CITY OF RICHMOND INVITATION TO TENDER

Contract T.3239

Contract: Blundell Road Sanitary Forcemain No.1 Road to Frobisher Drive

**Re: Contract T.3239
Addendum No. 1
Blundell Road Sanitary Forcemain: No.1 Road to Frobisher Drive**

OPTIONS FOR VALVE CONNECTION IN EXISTING FRP FORCEMAIN

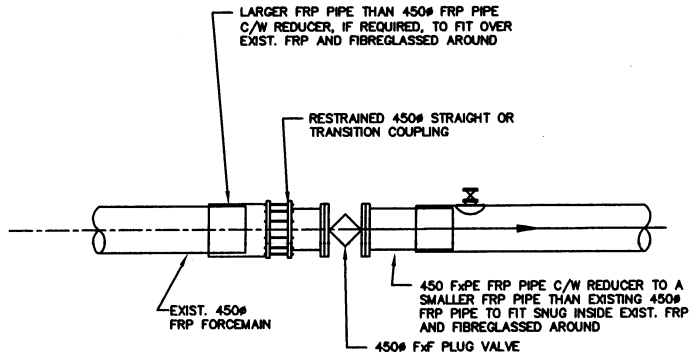
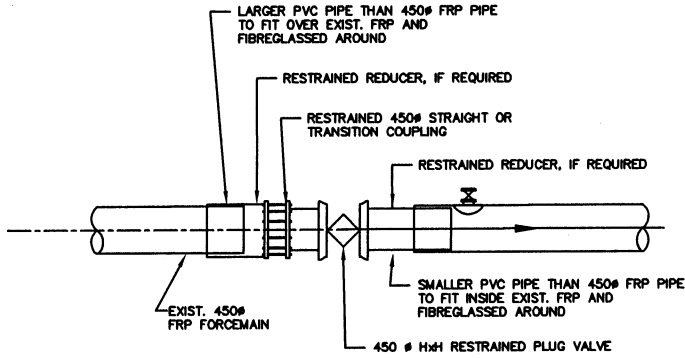
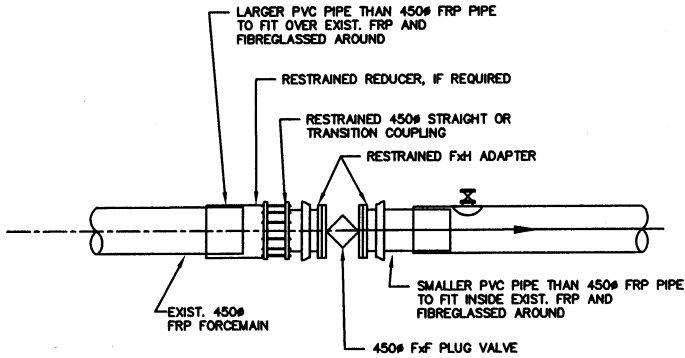
STEPS 5 & 6 are revised as per the attached detail for the west and east tie-ins to the existing FRP forcemain.

Materials to have the following specifications:

1. PVC pipe to be C905 – minimum DR 25.
2. FRP pipe to be minimum 150 psi pressure rating.
3. All FRP wrapping on project to be minimum 150 psi pressure rating.
